PCN-20190106 TE0724-02 to TE0724-03 Hardware Revision Change

Company	Trenz Electronic GmbH
PCN Number	PCN-20190106
Title	TE0724-02 to TE0724-03 Hardware Revision Change
Subject	Trenz Electronic TE0724 Hardware Change
Issue Date	20190315

#1 Replace DCDC U8 by TPS82140

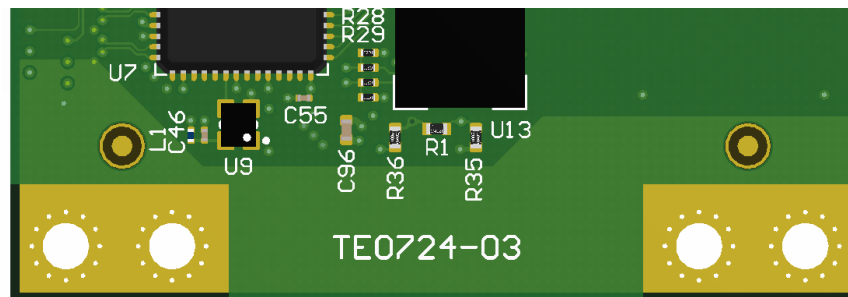
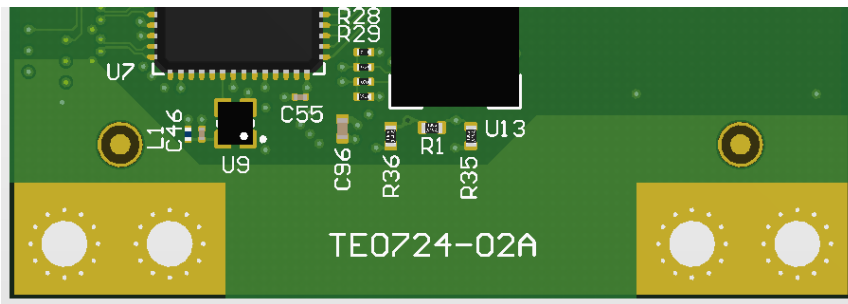
Reason: Applying additional capacitive loads prevents DCDC to start up

Impact: 3.3V power rail supports up to 2A total current and larger capacitive loads
